**COUNTY OF SAN MATEO
PLANNING AND BUILDING DEPARTMENT**

SUBJECT: Consideration of a Minor Subdivision, pursuant to Section 7010 of the County Subdivision Regulations, to subdivide a 11,957 sq. ft. parcel into two (2) parcels (Lot 1: 6,931 sq. ft., Lot 2: 5,026 sq. ft.), located at 2191 Mills Avenue in the unincorporated West Menlo Park area of San Mateo County.

County File Number: PLN2021-00086 (Amiri)

DRAWN: J.G.
CHECKED: C.B.
JOB No. 2021735
SHEET No. T-2
OF SHEETS

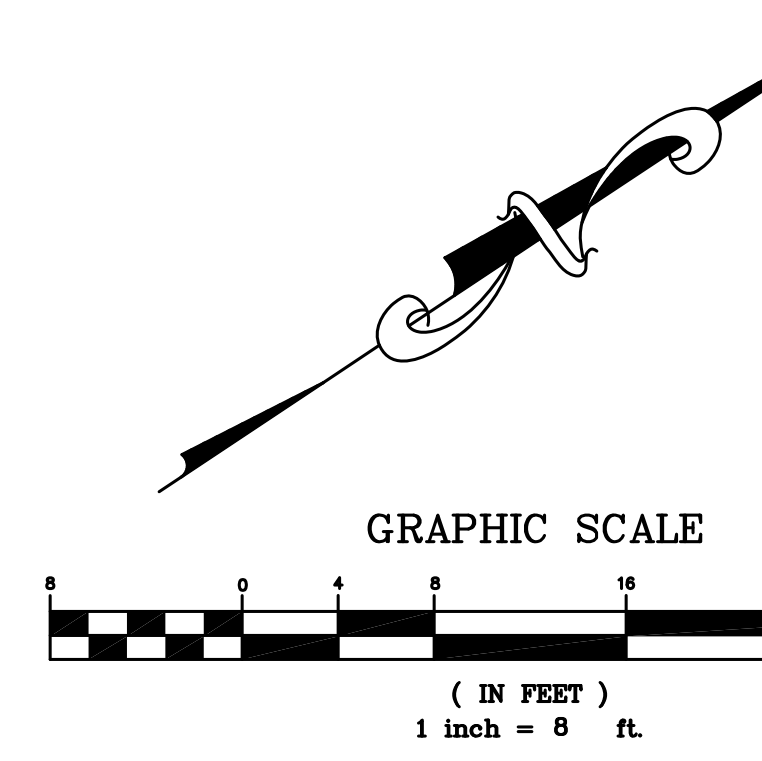
- 21) Plan Sheet T-2 includes information for end of a wall adjacent to the storm drain easement but does not provide similar information for beginning of wall. Details of retaining walls and landscaping within the storm drain easement shall be submitted to the Drainage District for review at the time of building permit submittal.

- 22) Plan Sheet T-2 shows a proposed 4" storm drain line within the storm drain easement. This 4" line should be located outside of the easement if possible.

- 23) Plan Sheet T-2 shows an existing retaining wall in the northwestern corner of Lot 1. Please indicate whether this retaining wall is to remain or be removed. Drainage District facilities shall be protected during any excavation to remove the retaining wall.
